ADDENDUM REVISION

**BRAMBLETON PUBLIC SAFETY CENTER
BELMONT RIDGE ROAD
BRAMBLETON, VIRGINIA**

SKE-12-1

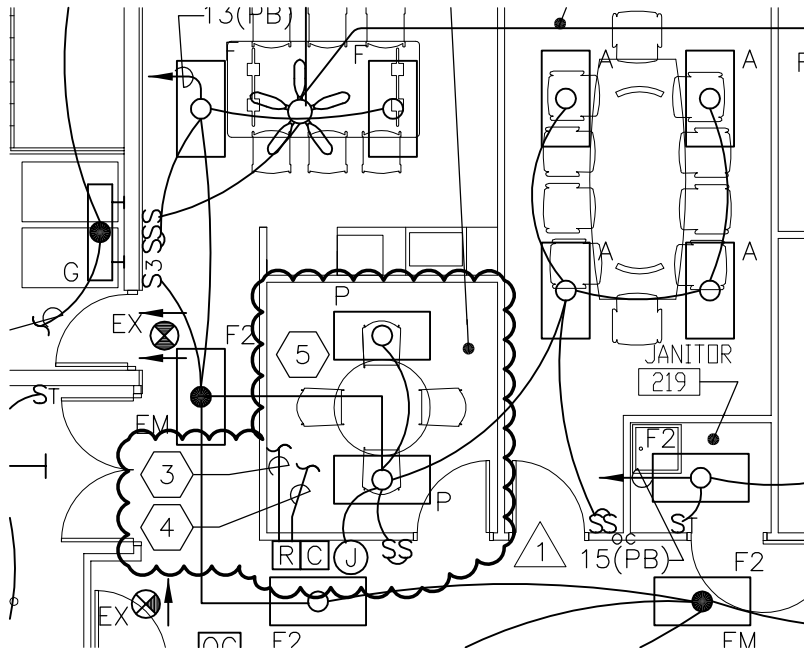
1 CONNECT TO LIGHT FIXTURES ON LANDING BELOW.

2 CONNECT TO LIGHT FIXTURES ON LANDING ABOVE.

3 TO CAMERA

4 TO MICROPHONE

5 THE ELECTRICAL CONTRACTOR SHALL PROVIDE A JUNCTION BOX, CONTACTOR, RELAY, AND WIRE/CONDUIT. LOW VOLTAGE WIRING SYSTEM SHALL BE ACTIVE WHEN LINE VOLTAGE IS ENERGIZED. THE LOW VOLTAGE CABLING FOR MICROPHONE AND CAMERA WILL BE BY OTHERS. PROVIDE MATERIALS & ACCESSORIES REQUIRED FOR A COMPLETE & SATISFACTORY INSTALLATION.
